## Acme Township VGT Development

### Storm Water Run-Off

October 14, 2014

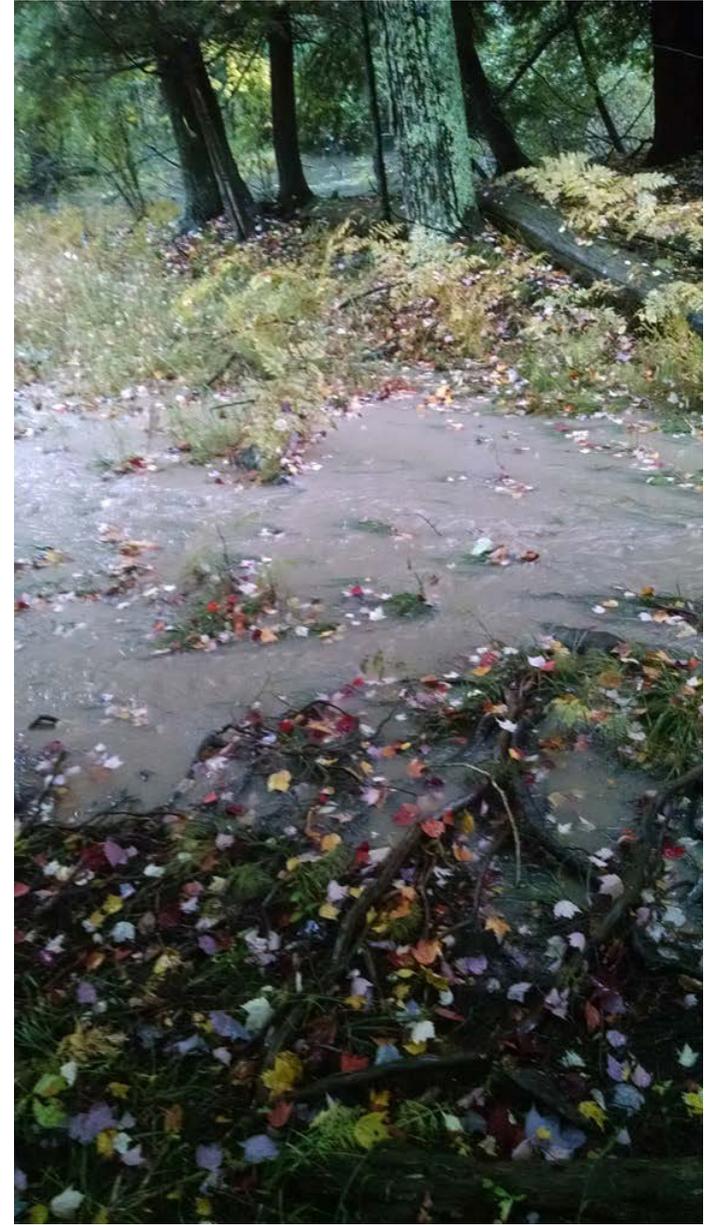
The easterly basin did not appear to be discharging at the time it was observed. However, the discharge swale was filled with murky water at the end of the discharge pipe giving the appearance the pond had discharged. The poly blocks in the swale appeared to clear the water approximately 10 feet downstream. But as the flow continued down the swale it picked up silt and by the time it got to the end it was once again "chocolate" color. At the end of the swale the silt fence were separated and water was flowing through the separation in the silt fencing. In addition the straw bales were either missing at the opening of the silt fencing or being overwhelmed by the discharge.

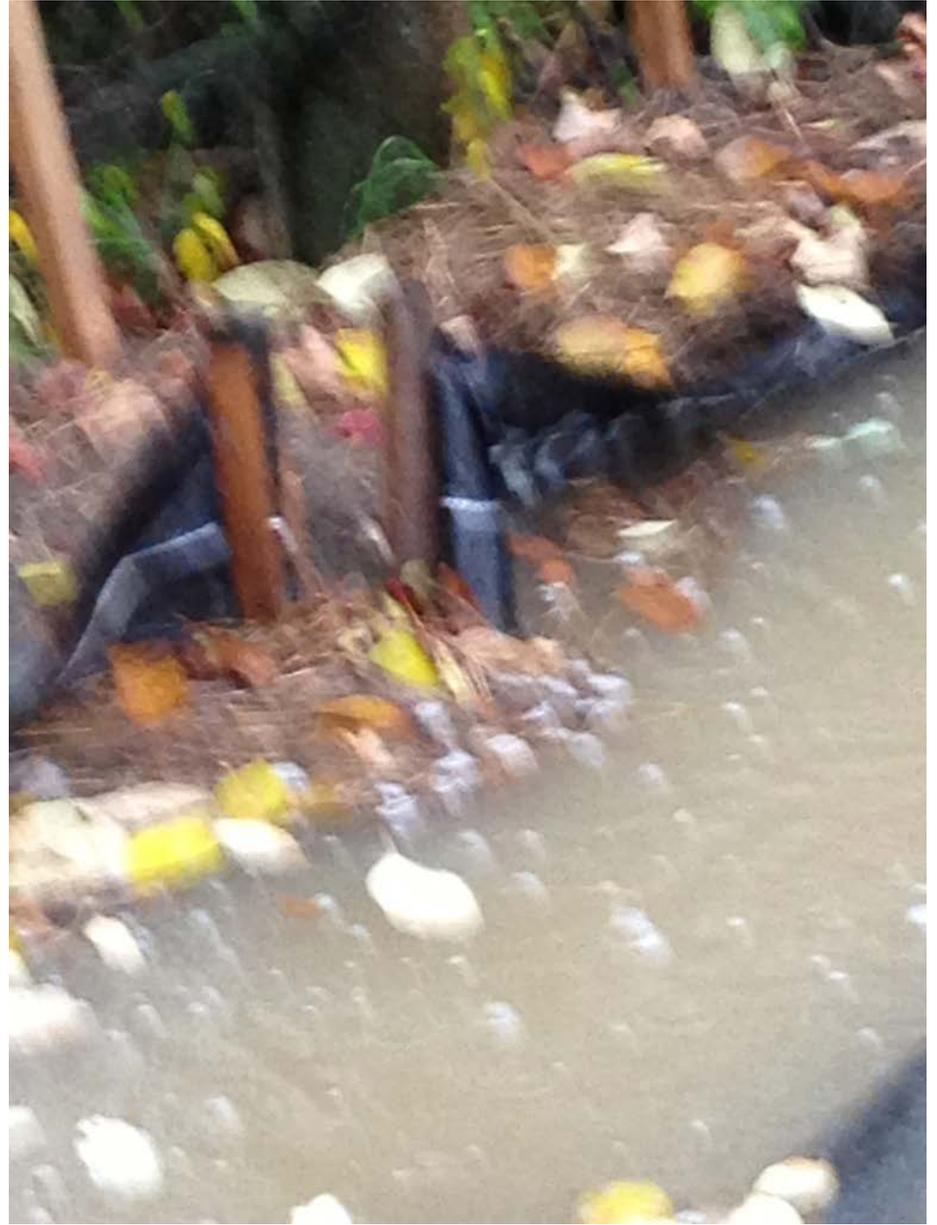
The second discharge noted was at the wetland low area located between the east and west basins. The soil stockpiled along the south side of the site road has not been stabilized yet. Water pools at the base of the soil pile at the top of the wetland. Water is contained by silt fencing and two rows of straw bales. However, the water volume was over topping the silt fencing and first row of straw. It then was flowing under the second straw and creating a stream flow of water with silt into the wetland.

In addition, Bernie Jacobson observed a discharge to Acme Creek at the southeast corner of the site. Silt fencing at this location did not appear to be properly toed in.
